N40/ED 04

Information Only Service Note

N1045B 60 GHz, 2/4 Port, Electrical Remote Sampling Head Module

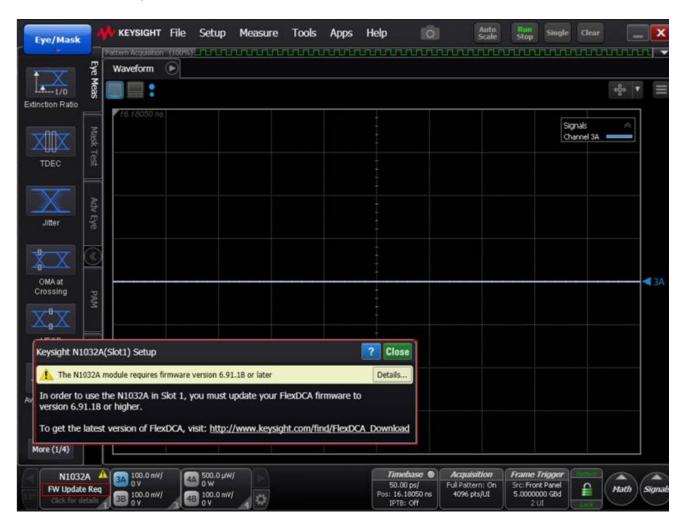
With the module installed in a DCA mainframe, if a message like the one below is displayed, FlexDCA must be updated to the indicated version (or later):

To update FlexDCA software, download from www.keysight.com/find/flexdca_download and install. While only the indicated version is required, updating to the latest version is recommended.
